Indexes, Double Dr. Cab., FS (F100,F120)
PI409, Issue 4, 28-10-04
Pertronic Industries Ltd

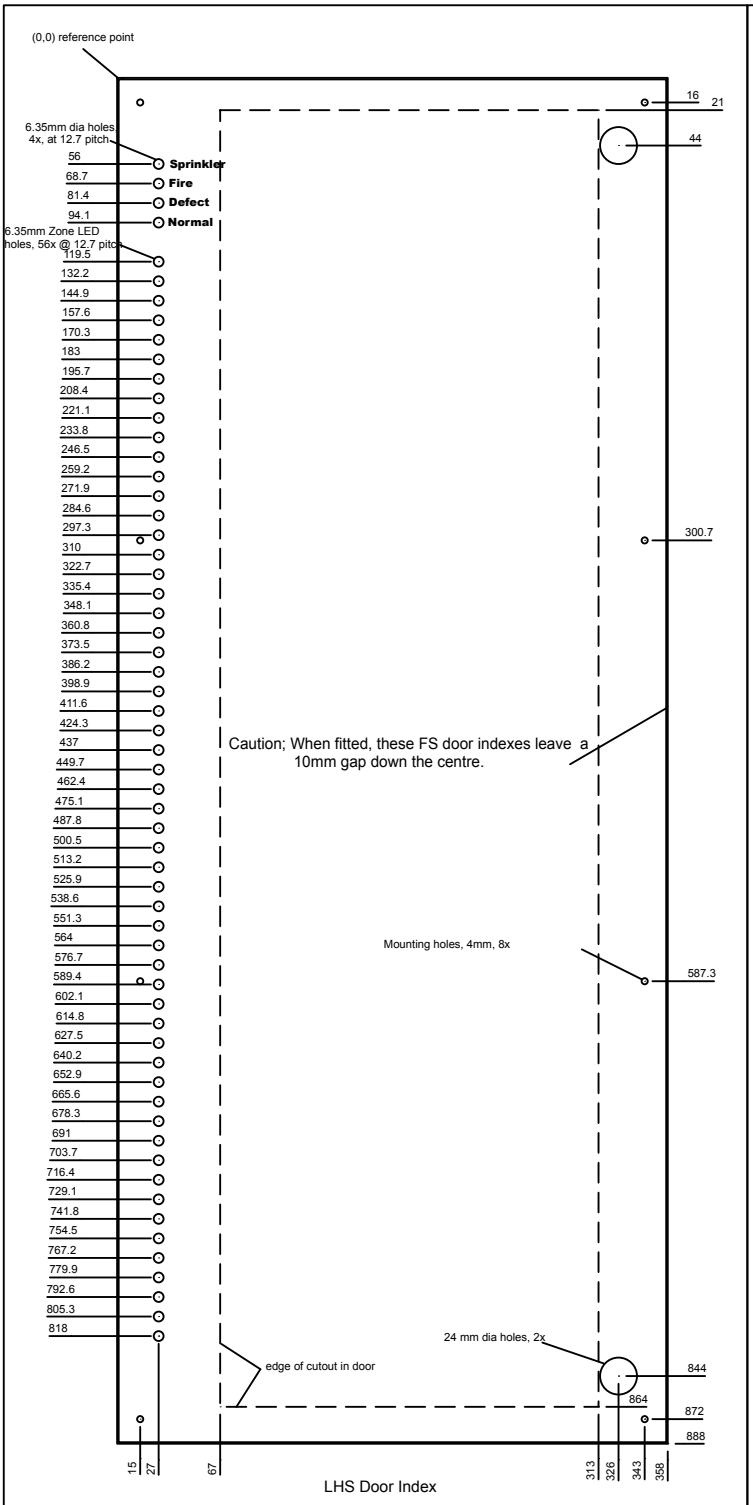
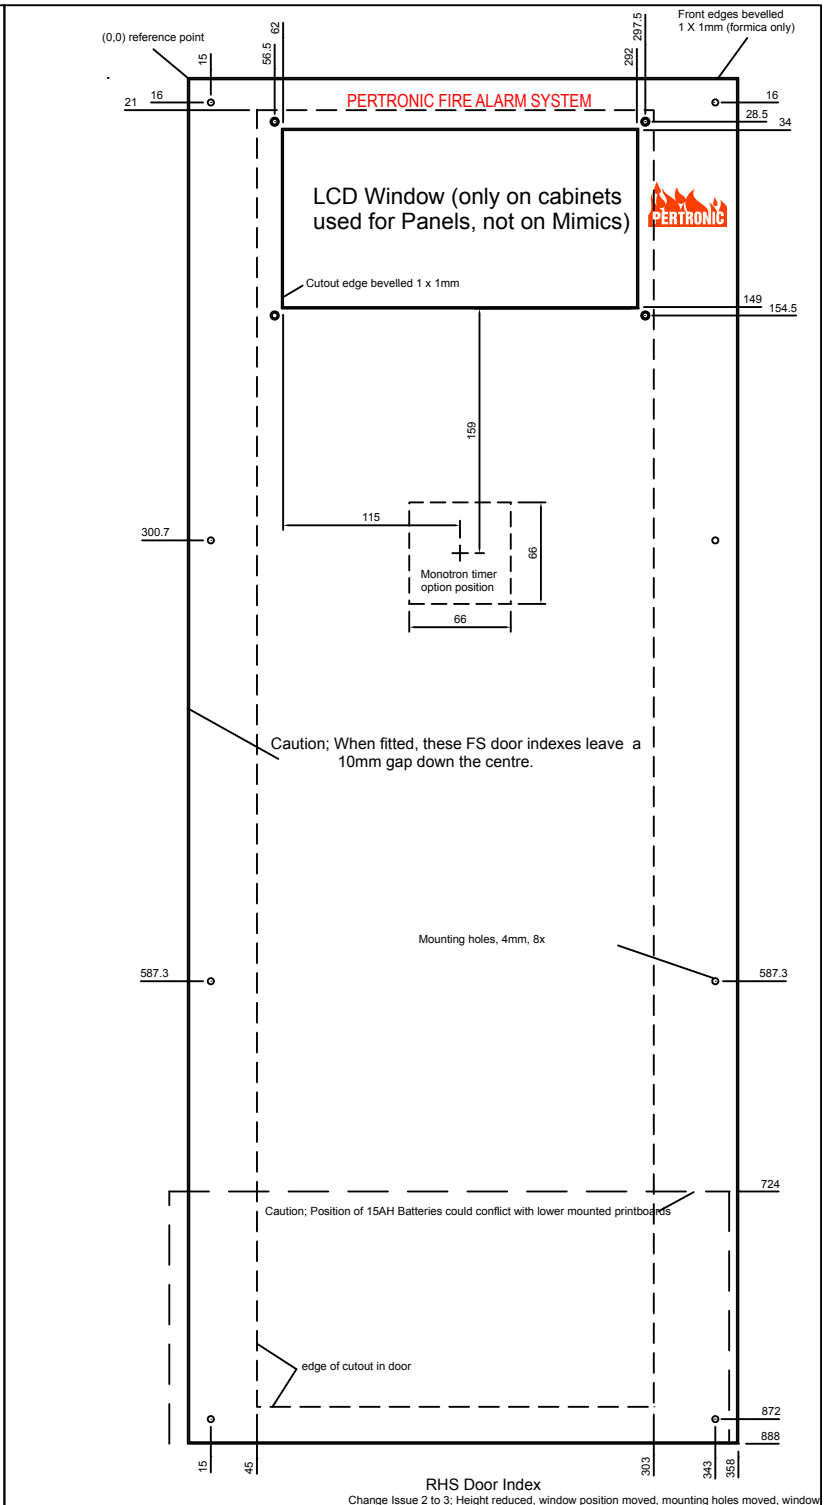
Change Issue 2 to 3; Height reduced, window position moved, mounting holes moved, window repositioned 3mm to right
Issue 4 changes; Material changed to Acrylic,eight mounting holes per door changed to 4mm

Material; 3mm White Acrylic (or engraving grade Formica W/B/W Vallum Finish)
(Blank Code INPI409FBLANK)
